ADDENDUM NO. 1

**TRI-COUNTY SCHOOL JR-SR HIGH SCHOOL BACKPACK ADDITION &
NEW MAINTENANCE FACILITY
Wolcott, IN 47995**

ADDENDUM ONE

Addendum One (AD.01) to the drawings and specifications prepared by Gibraltar Design for **Tri-County Jr/Sr High School Backpack Addition & New Maintenance Facility** for Tri-County School Corporation, Wolcott, Indiana.

P1 - WALL FINISH
C1 - FLOOR FINISH
B1 - BASE FINISH
--- - MISC FINISH INFORMATION

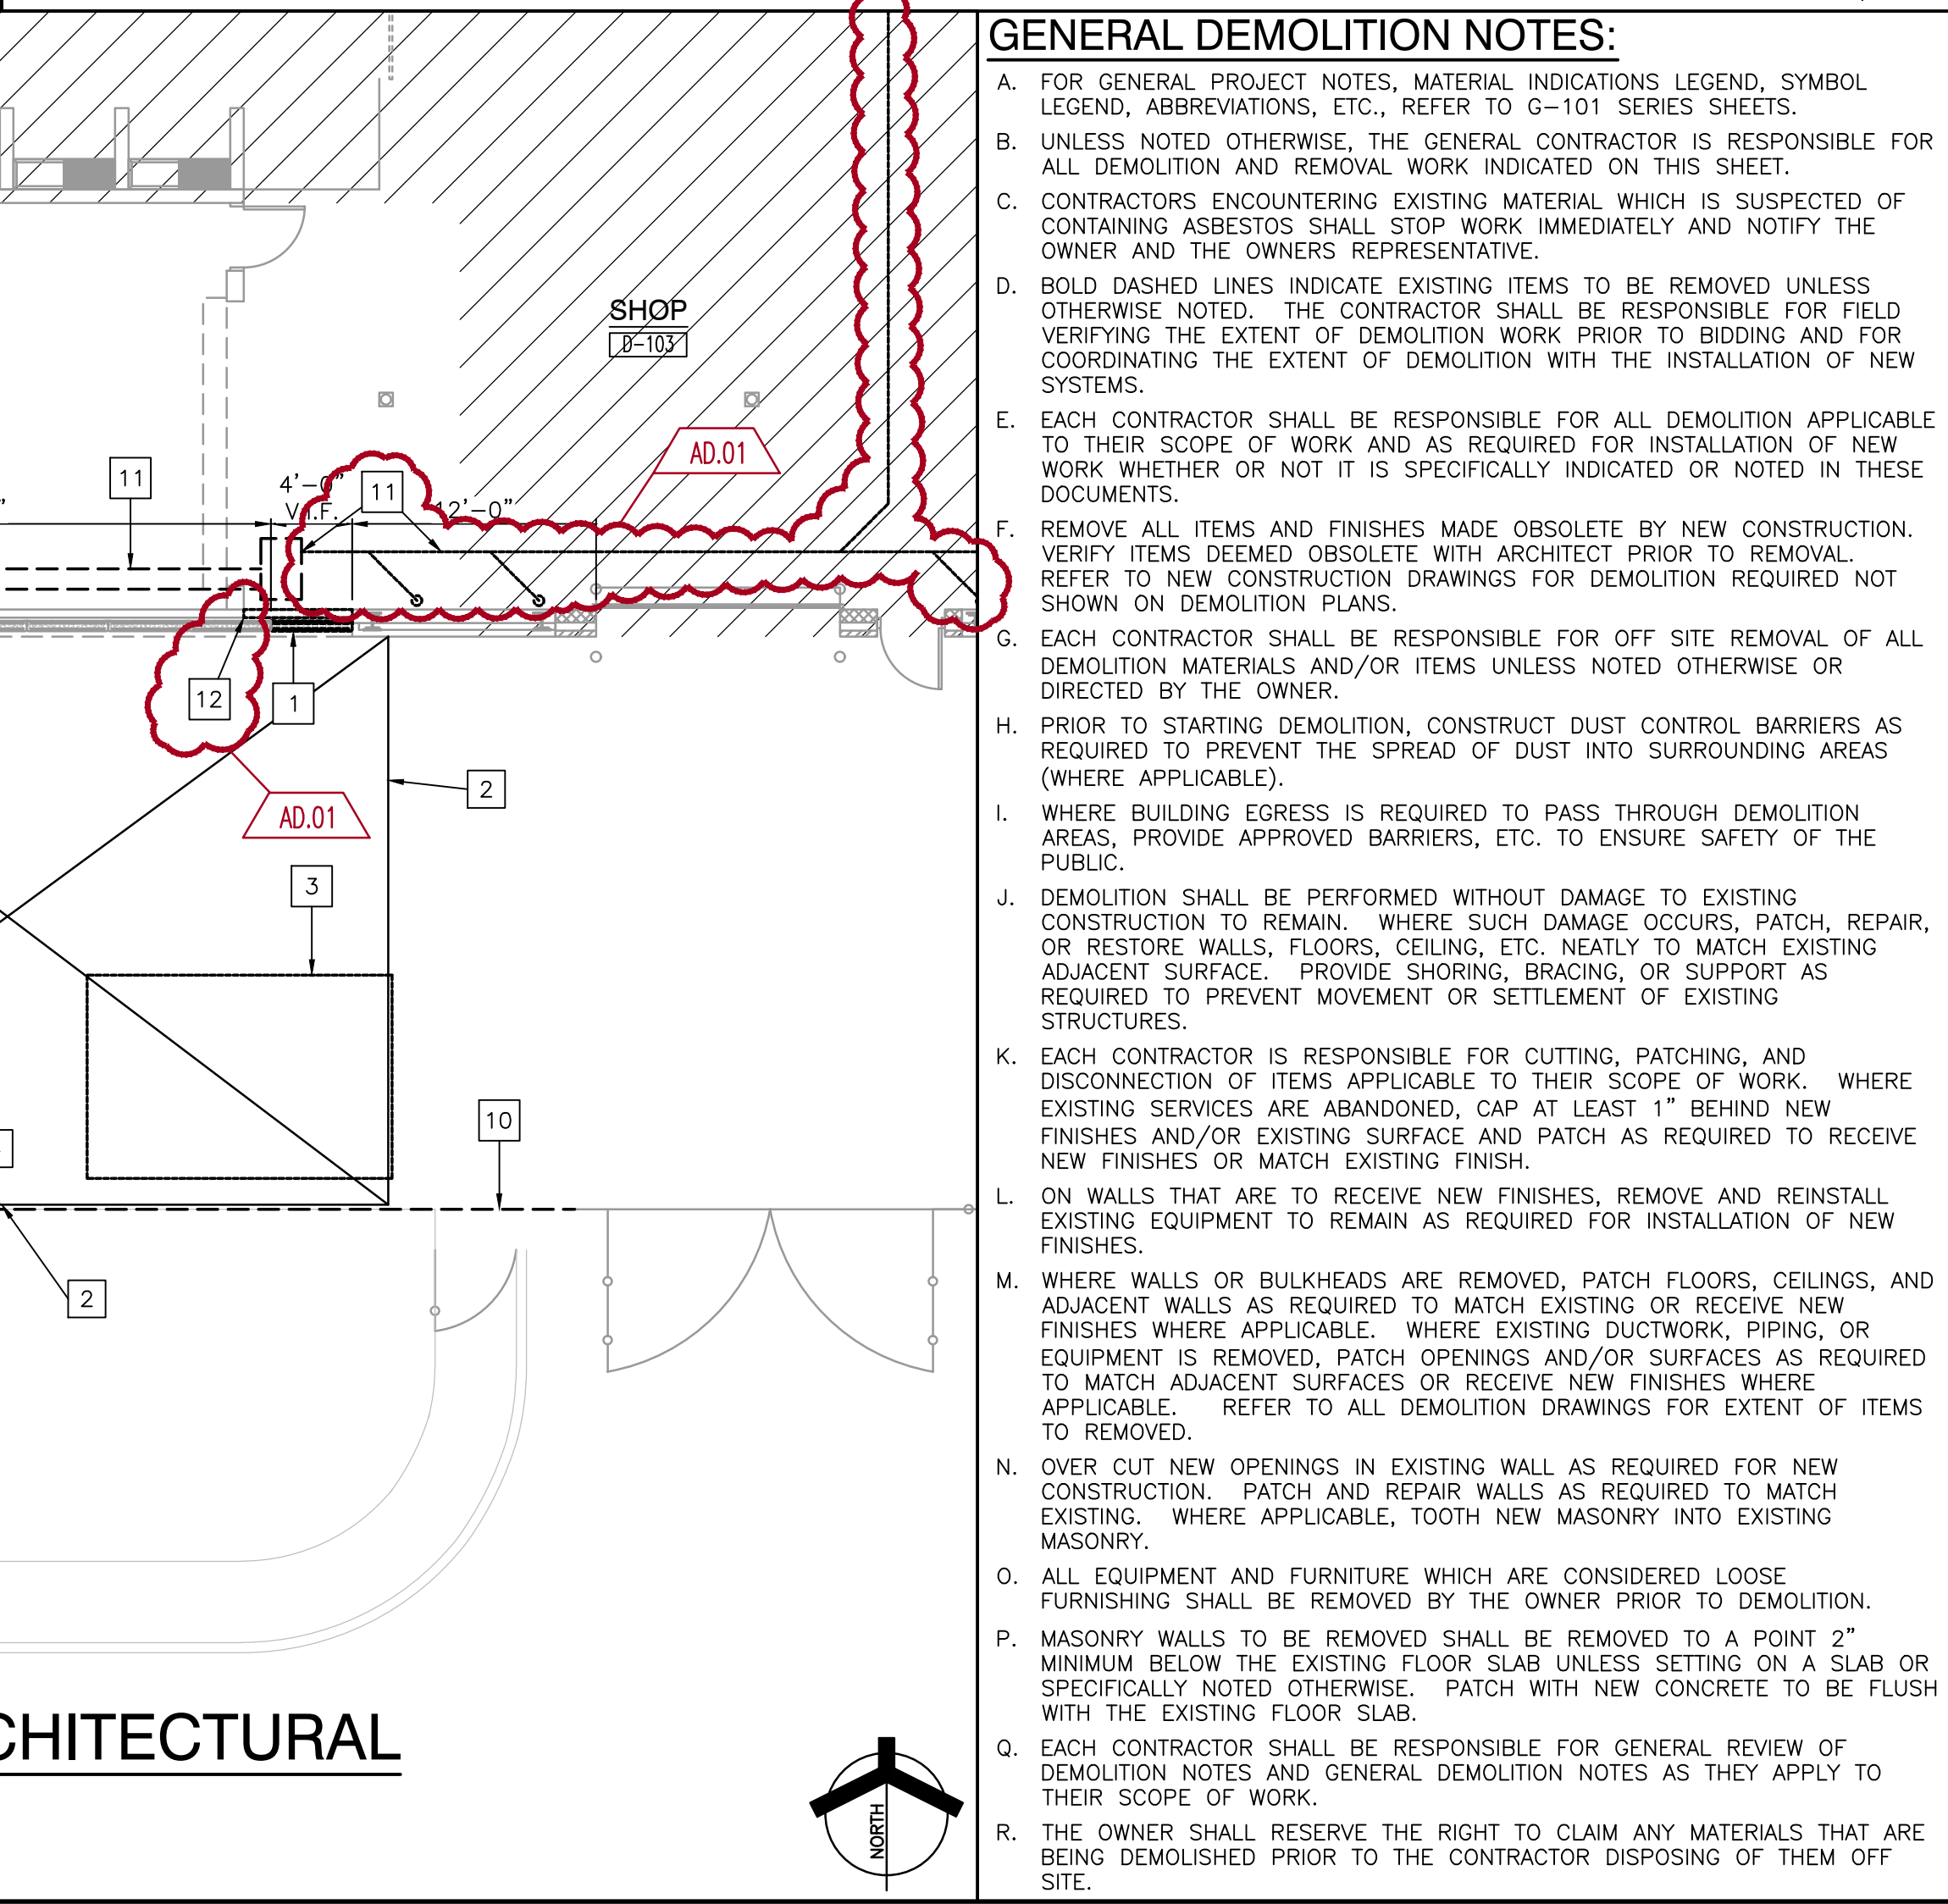
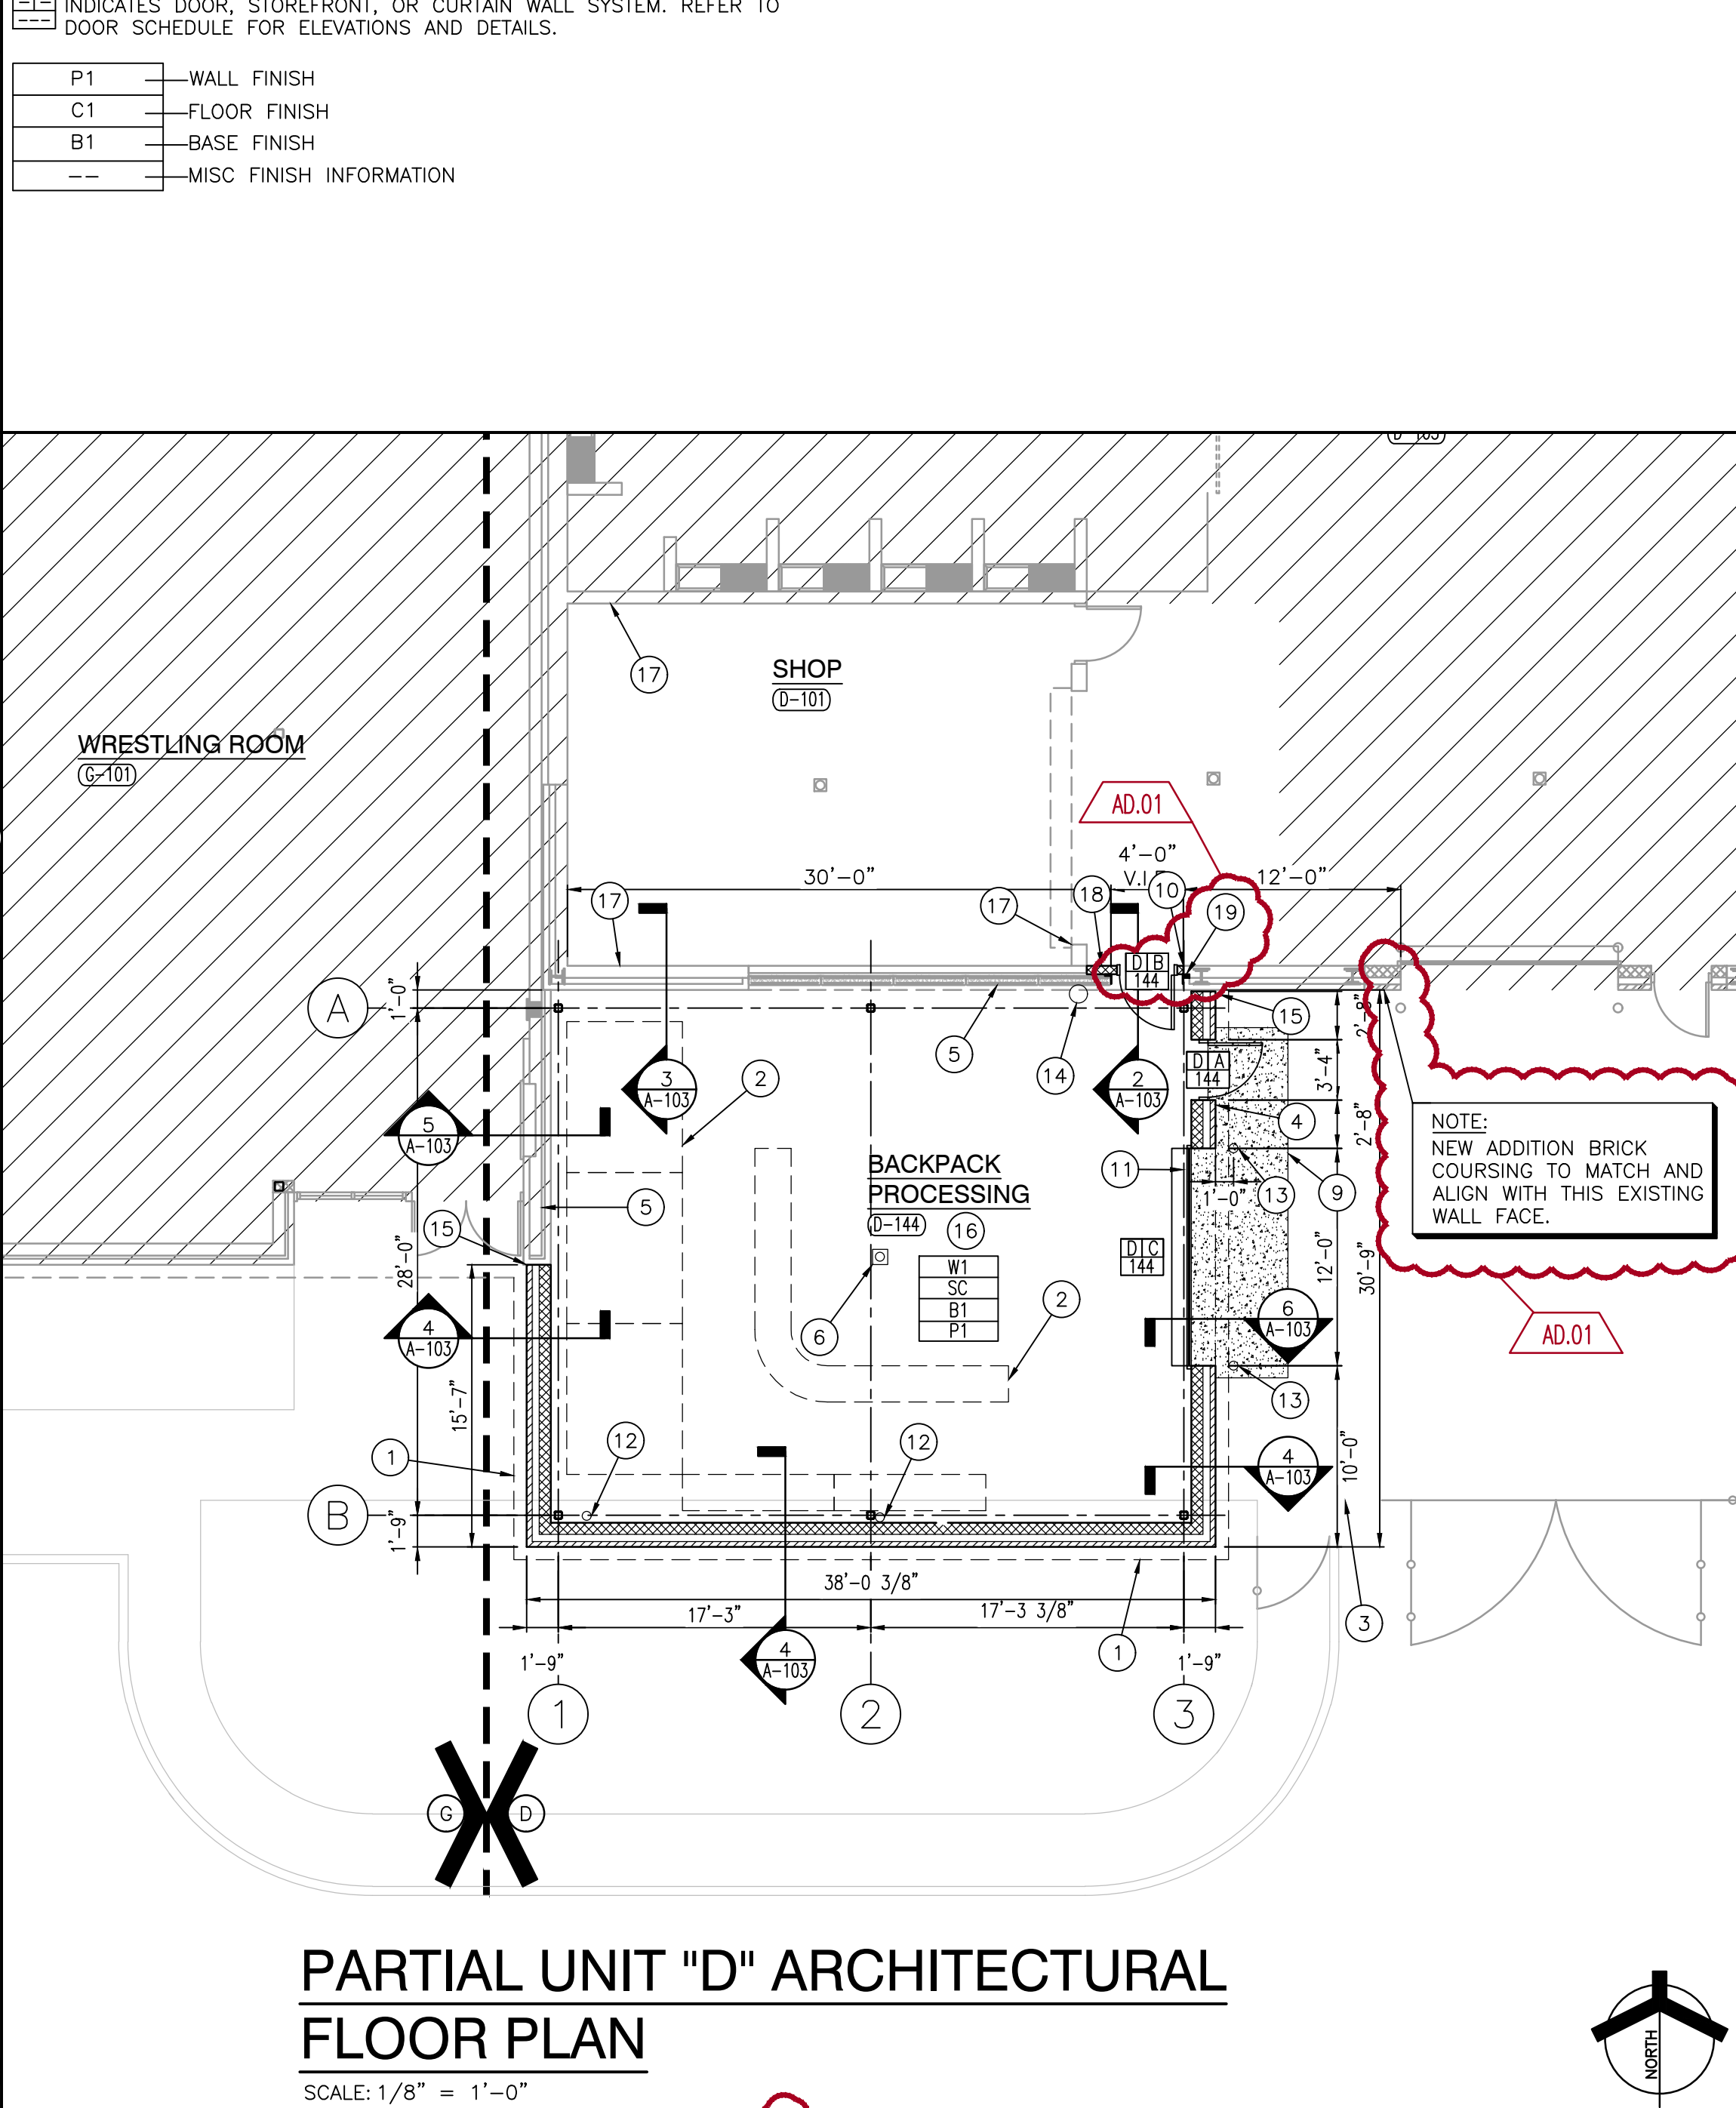
- A. Revised plan notes.

5. Sheet A-103

- A. Revised Wall section 2
